Our Ref: SSD-2026/2
Our Contact: Angela Lazaridis- (02) 9562 1719

Bayside Council submission on State Significant Development Application for 19A Evans Avenue, Eastlakes (SSD-105575706)

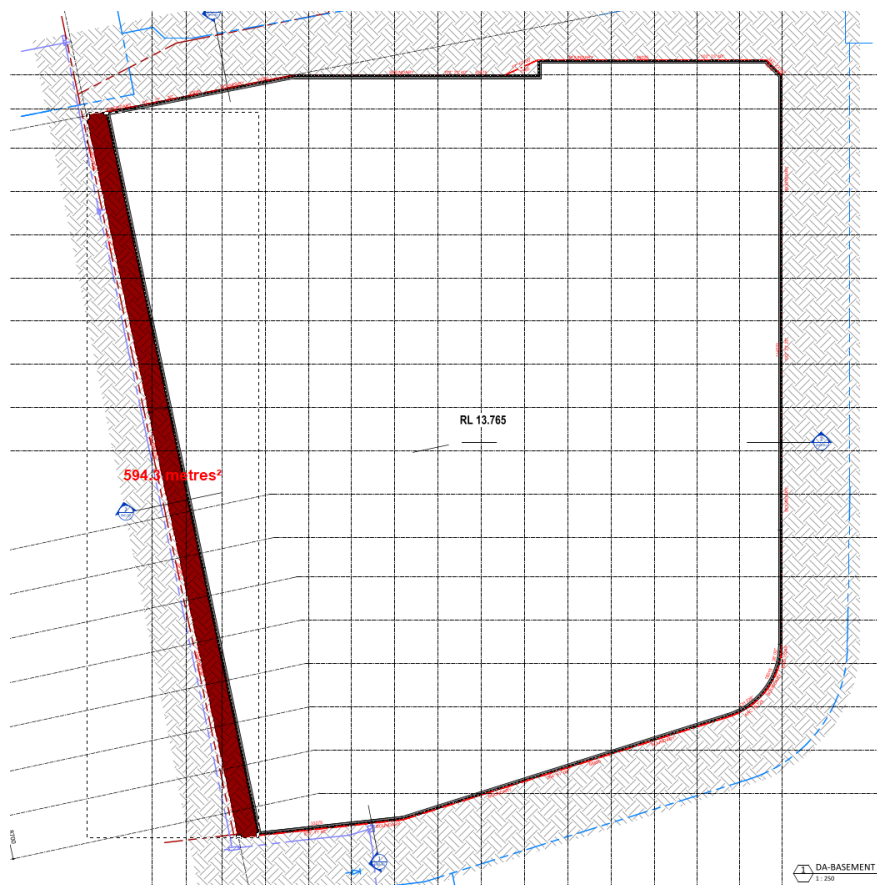
The submitted plans identify a 4-metre deep soil setback only along the western boundary adjoining Jack Munday Reserve. No equivalent landscape setbacks are shown along the remaining street frontages to Evans Avenue and Barber Avenue. Instead, the proposed basement structure appears to extend to, or close to, the site boundaries, significantly constraining opportunities for deep soil planting and future canopy tree establishment.

Council notes that only 594.3 m² of deep soil area is proposed across the 17,958.3 m² site, representing approximately 3.3% of the site area. This falls significantly below the Apartment Design Guide benchmark of 15% deep soil landscaped area (as site area >1500sqm). The proposed extent of excavation and four-level basement therefore raises significant concerns regarding the site's ability to accommodate meaningful deep soil landscaping and large canopy trees as part of the future Major SSD application.

Council recommends that continuous 3 m wide landscape setbacks be provided along the remaining Evans Avenue and Barber Avenue frontages, free of basement encroachments

and other structural constraints. These areas should prioritise deep soil planting and the establishment of large canopy trees (minimum 200 L pot size) to support long-term canopy cover, urban cooling, and the intended landscape character of the Eastlakes Shopping Centre area.

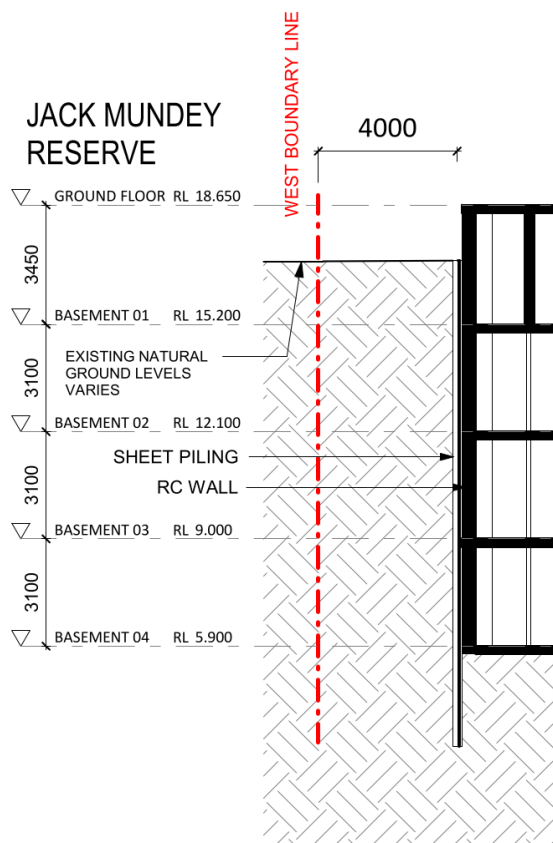
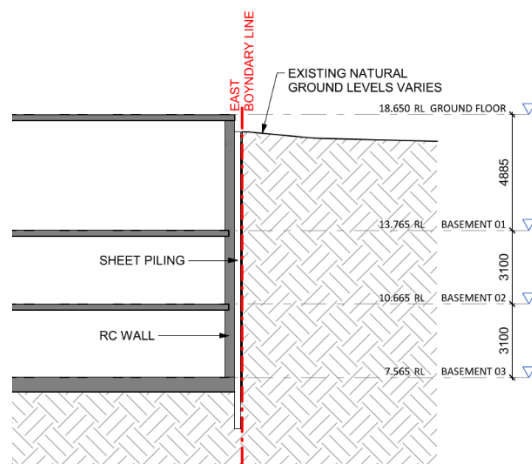
The plans indicate that consent is sought for the ground level slab. The ground level slab is shown to be significantly higher than the surrounding footpath and park levels which is

not acceptable as this will provide a poor interface with the public domain. Currently the ground floor is approx. 1.5m - 2m higher than the Barber Avenue footpath (southern boundary) and 2m higher than the park levels along the western boundary which is an excessive level difference. The plans are to be revised to revise the ground floor level to provide an acceptable interface with the surrounding public domain.

These sections below demonstrates a poor relation between public domain and the shops at ground floor given the substantial level difference between ground floor and footpath level/park level.

Design changes need to be implemented to increase deep soil landscaping and provide suitable setback to the street.
